Groundwater Application Review Summary Form

Application # G- <u>19421</u>
GW Reviewer <u>Travis Brown</u> Date Review Completed: <u>12/20/2024</u>
Summary of GW Availability and Injury Review:
Sammary or Cit / transcript and many nevieur
Groundwater for the proposed use is either over appropriated, will not likely be available in the
amounts requested without injury to prior water rights, OR will not likely be available within the
capacity of the groundwater resource per Section B of the attached review form.
Summary of Potential for Substantial Interference Review:
\square There is the potential for substantial interference per Section C of the attached review form.
Summary of Well Construction Assessment:
☐ The well does not appear to meet current well construction standards per Section D of the attached
review form. Route through Well Construction and Compliance Section.
This is only a summary. Documentation is attached and should be read thoroughly to understand the

PUBLIC INTEREST REVIEW FOR GROUNDWATER APPLICATIONS

Application G-19421 Date: 12/20/2024 Page 4 of 9

Hydrograph

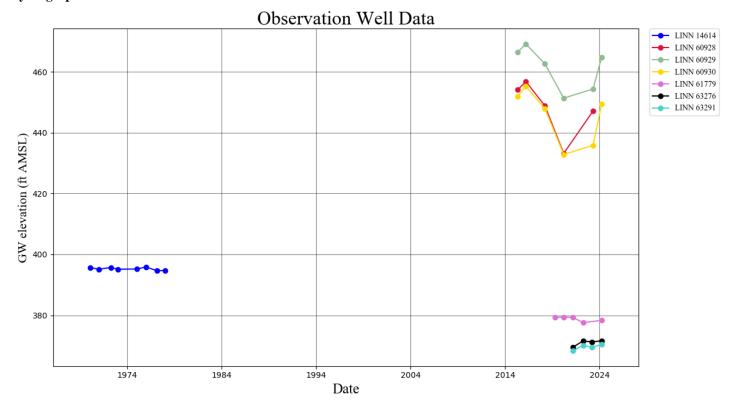
Water level data in nearby wells is limited, with short periods of record (see attached Hydrograph). Furthermore, the wells with available time-series water level data likely do not access the same aquifer as the POA well, instead being open to the alluvial aquifer system (LINN 14614, 61779, 63276, and 63291) or to the more basalt/volcanic-dominated bedrock further upstream to the southeast. However, all of the nearby wells for which water level data is available generally show long term stability, which supports the conclusion that the source of water to wells near the Calapooia River is capture-dominated. Based on the available evidence, the groundwater resource is not over-appropriated.
